Q1. What are the differences between Step 0 and Step 1 devices?

Q8. Why is Xilinx standardizing to 10-layer for Virtex-5 packages with more than 1000 pins?

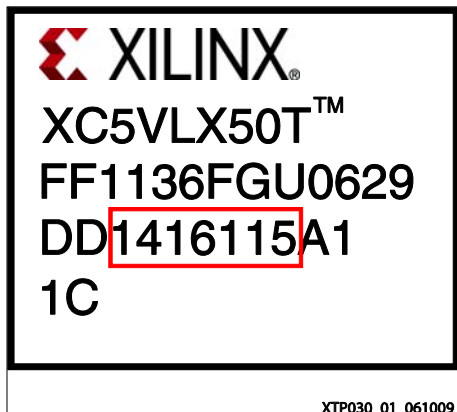
- A. If you ordered a Step 1 device (ordering code "S1" appended to the end of the standard ordering part number), you have a device with a 10 layer package.
- B. If you are unsure of the ordering code, to trace the packages in your possession, please contact Xilinx Customer Service at csgroup@xilinx.com, and provide the 7- digit Lot ID (see example top mark below). Xilinx Customer Service can identify if the order was shipped with 8-layer or 10-layer packages.
